— PLANNING AND ZONING COMMISSION —

May 12, 2020
6:00 P.M.
City Council Chambers

Agenda Item: 7.C. Consider recommendation on request for approval of a Preliminary Plat for Ashton Park Plat 7.

Preliminary Plat, Utility and Grading Plan, Sheet 3

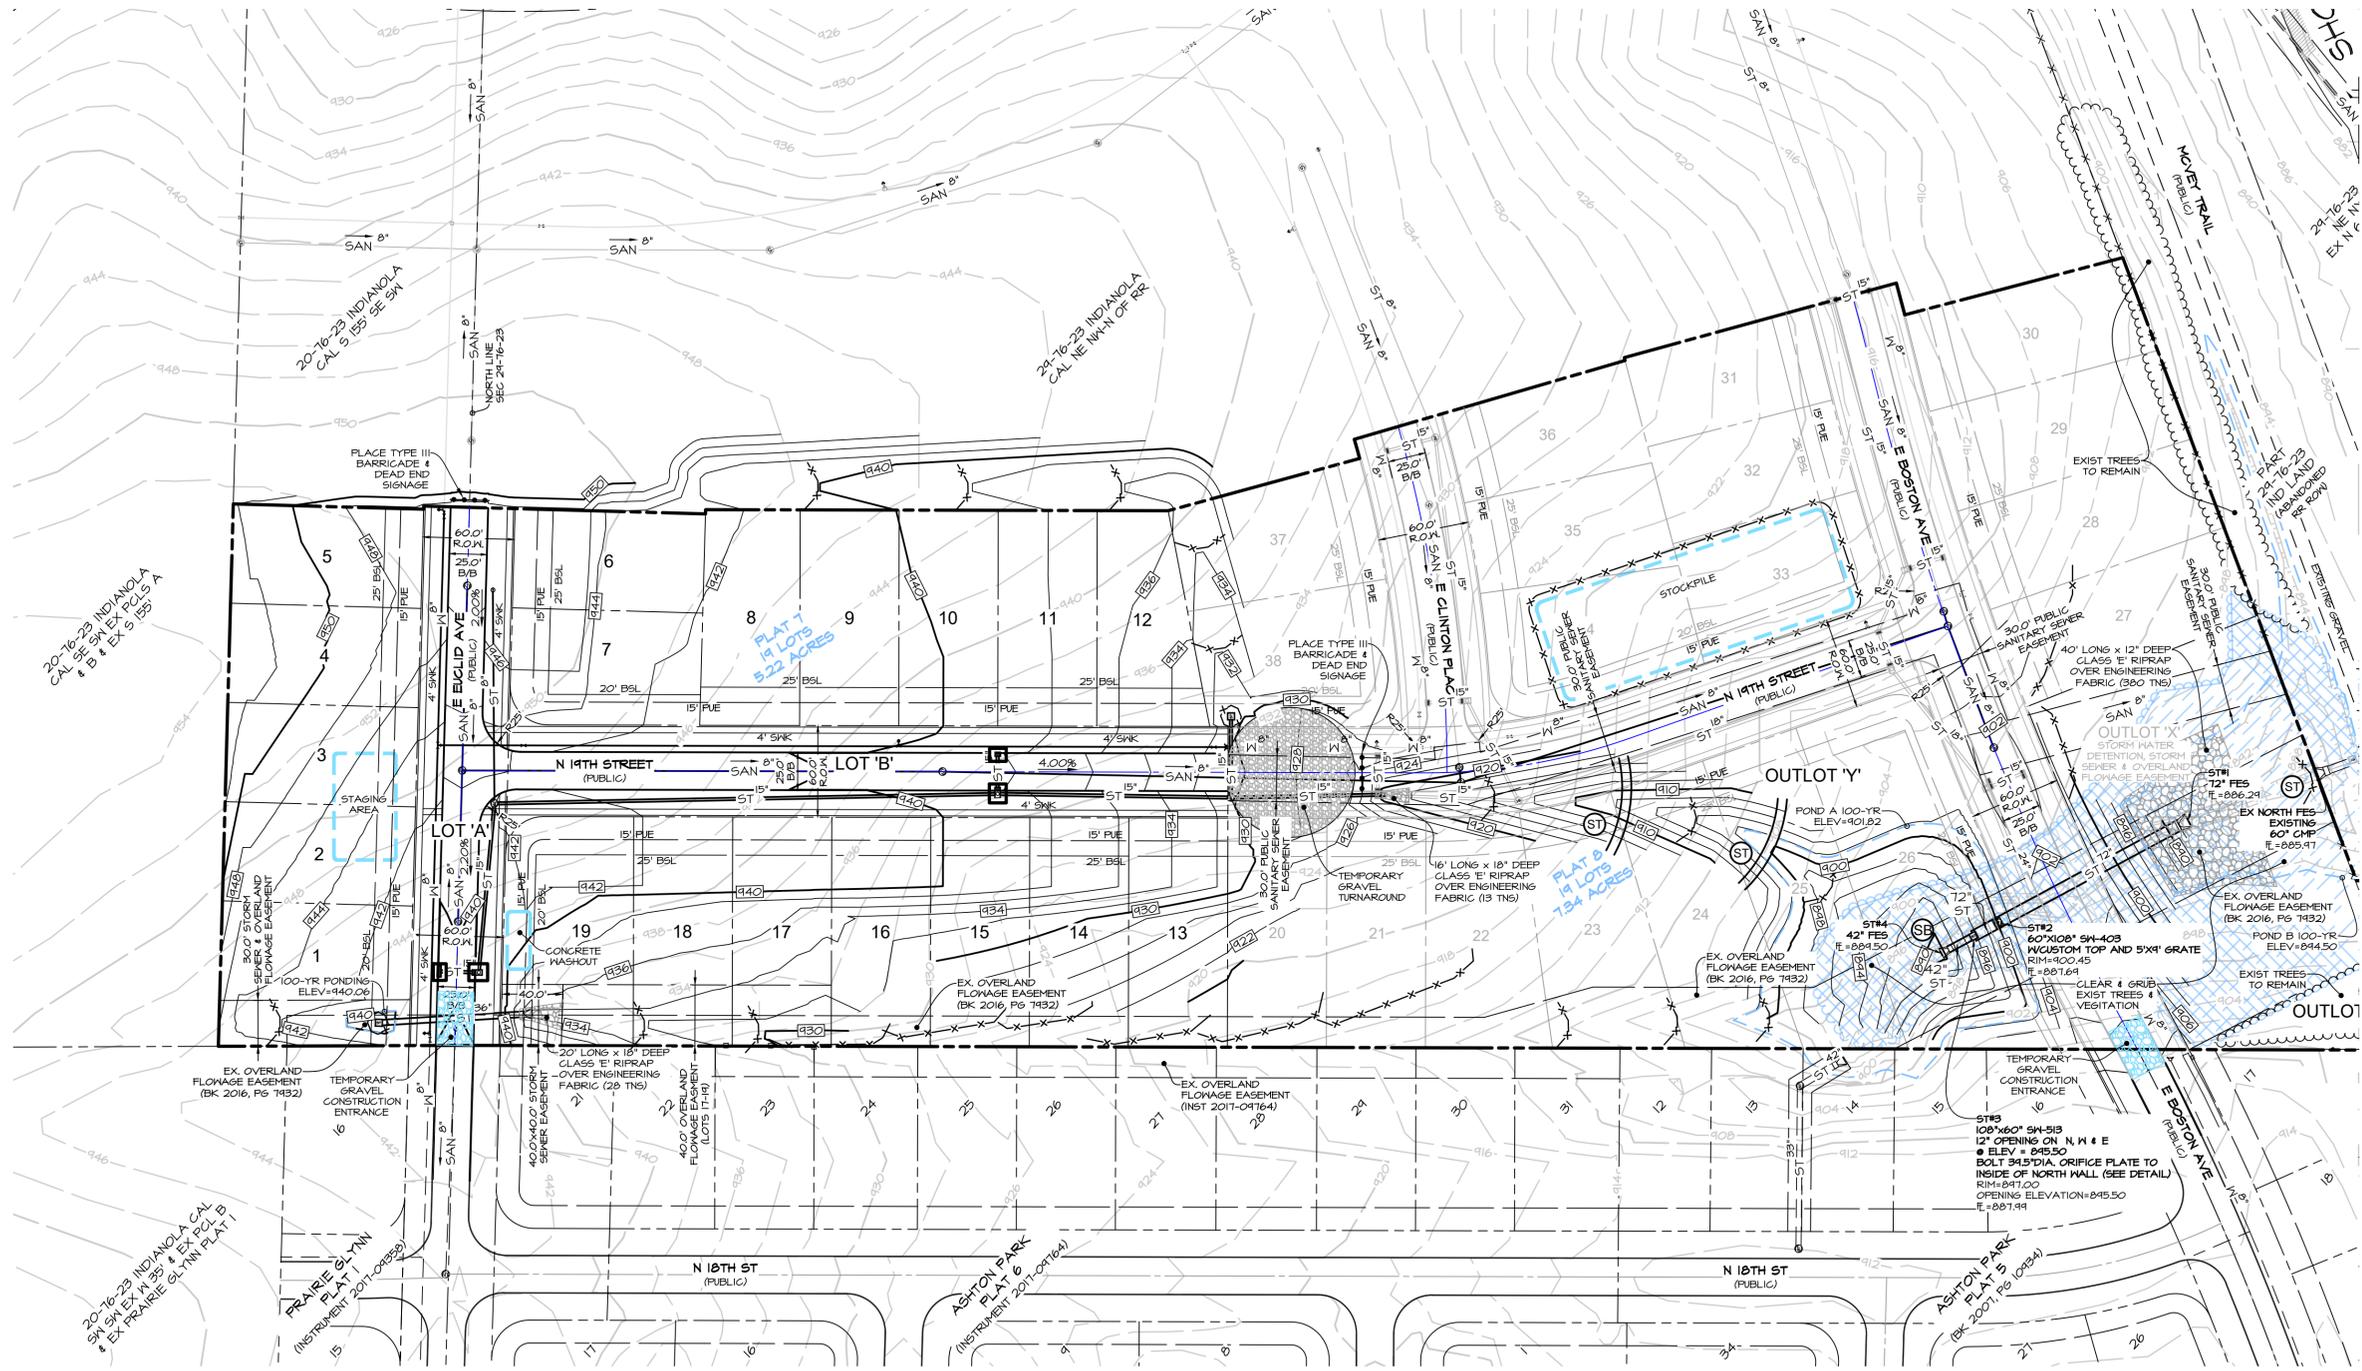
1. There are several areas within the plat and along the boundary where surface water is to be conveyed.
 - a. The rear yards of lots 13-19 note a previously dedicated easement. The 100-year storm will need to be conveyed in this area and construction plans should indicate the limits of the storm water. **Agreed. The stormwater limits will be indicated on the construction plans.**

- b. East of the plat boundary a drainage swale is proposed near the rear of lots 6-12. A temporary and permanent drainage easement will be necessary. Consideration should be given to centering this swale along the boundary line. **The developer owns the ground to the east and plans to have that swale be a permanent easement in a future plat to the east. We prefer to have the swale on one side of the rear lot line so that franchise utilities can be located on the west side of the rear property line. The franchise utilities also prefer to have utility boxes located outside of the flowage easements.**

2. The proposed drainage ditch to be constructed across future plat 8 traverses across future lots 22-26. This ditch may cause future homes to have issues with foundation settlement depending on elevation of structure. Constructing buildings within the future plat will require precaution. **We plan to specify over-excavation of the swale area, recompaction to 95% standard proctor density and additional soils testing when plat 8 develops.**

4. There is significant drainage area north of Euclid Avenue and needs to be routed through the proposed 36" storm sewer at the northeast corner of the plat. Calculation of the 100-year storm elevation should be calculated with consideration of the necessary grading plan, such that lot 1 will not be impacted or lot 16 of Ashton Park Plat 6. **Channel and weir calculations have been added to the SWMP and we have provided a catastrophic flow route that goes to the low point intakes on E. Euclid Avenue. We will require a minimum opening elevation on this lot and any other lot that would potentially be affected by stormwater flowage. This documentation will be provided with the construction drawings and final plat.**

5. The area between Boston Ave and McVey Trail will need additional consideration related to hydraulics. The construction plans may be used to provide more details, since these improvements don't have an impact directly on plat 7 lots. The proposed 72" pipe discharges into Outlot X prior to being conveyed under the McVey Trail via a 60" CMP. The likely pooling between the 72" and 60" should be expected. These two pipes are only 80' apart and consideration of connecting these pipes could be evaluated. This may result in less required easement dedication and more buildable area. If the storm sewer is not connected, the rip rap should be expanded to protect the inlet of the 60" CMP trail crossing. If this area is used for future storage, evaluation of trail embankment will be required to determine suitability.

An overall grading plan for the entire 36.06-acre parcel was emailed to you on 5/5/2020. This shows our future plans to expand the detention area (Outlot 'X', Plat 8). The pipes between the ponding areas will not be connected so that additional detention can be provided south of Boston Avenue. We have extended the riprap to the flowline of the existing 60" culvert as requested.
